ADDENDUM TO THE CONTAMINATION ASSESSMENT REPORT TANK SITE 1343 NS
MAYPORT FL
6/25/1999
BHATE ENVIRONMENTAL ASSOCIATES, INC.

ADDENDUM TO THE
CONTAMINATION ASSESSMENT REPORT
TANK SITE 1343

RE: Site Assessment Report Addendum Tank Site 1343, Naval Station Mayport,
Mayport, FL

WATER TABLE CONTOUR MAP
 2/19/99

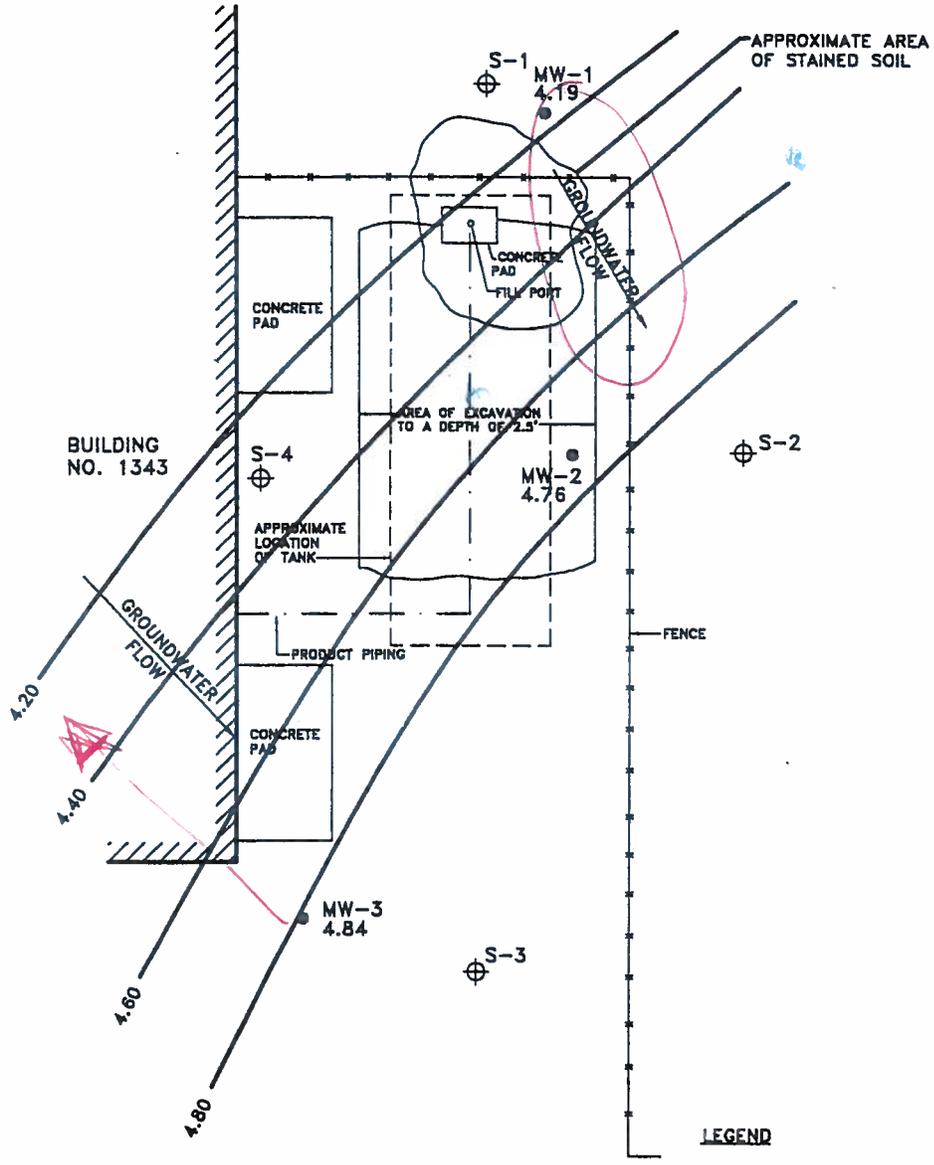
1. Examination of the ground water flow data on Figure 1 indicates that the flow direction is opposite to that indicated. For the record, the three wells are not placed optimally for ground water flow direction determination. Were it not for the free product observed in monitoring well MW-1, this point would be relatively minor; however, since it was observed, it is important. Please determine the ground water flow direction, including using any new wells as part of the data acquisition. Prepare and present a revised ground water flow direction determination, modifying Figure 1.
